**AUSTIN ROVER**

**BULLETIN**  
**MONTEGO TECHNICAL**

**DOOR HINGE WELDS - INCOMPLETE**

fig. 4/1

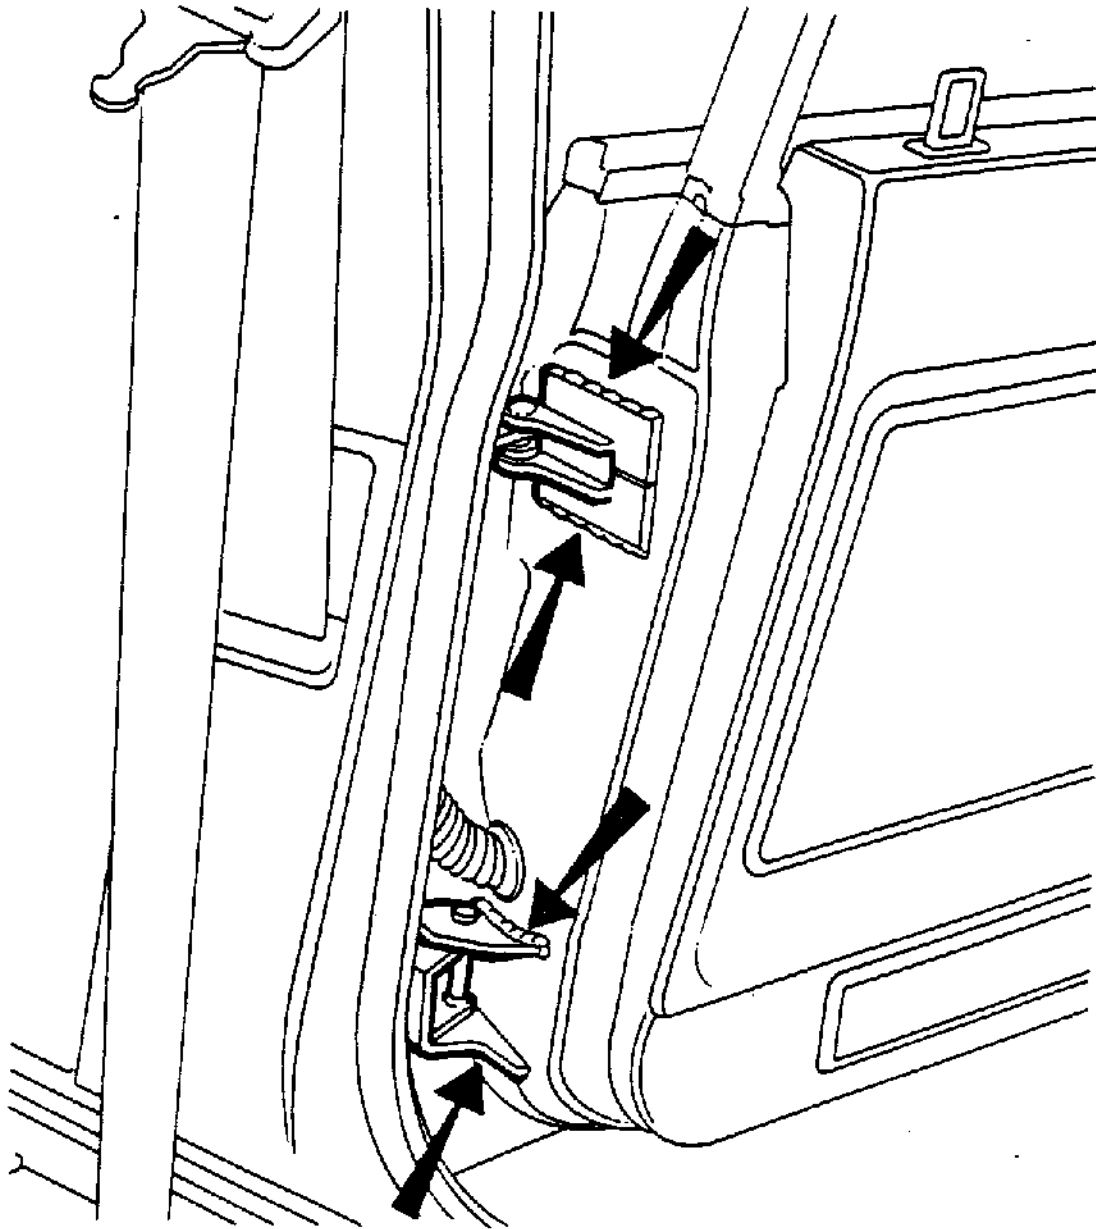
Welds between hinges and doors imperfect or incomplete.

Robot welder not operating correctly.

- 1 Examine welds (arrowed in illustration) between the hinges and the door on all four passenger doors (two doors only on van) and the door. Look for missing welds and for any weld in which the filler metal has not made a proper bond with the door panel.
- 2 Any missing or suspect weld should be dealt with as follows:
  - a. remove trim pad from door and disconnect wiring, where fitted.
  - b. remove door from car.
  - c. ensure that nothing within door will be damaged during welding.
  - d. use mechanical means, e.g. small rotary wire brush,

Examine welds as described below and re-weld as necessary.

to remove paint from area to be welded and make repair as necessary, using CO2 welding.

- e. clean off welded area, degrease and repaint using etch primer and normal repainting process. Treat similarly bare area on body where hinges are bolted and mating faces of hinges.
- f. treat inside of door where hinges are attached with Unipart cavity wax.
- g. refit door to car and adjust as necessary.
- h. make good paint damage to bolt heads.
- i. re-assemble door.
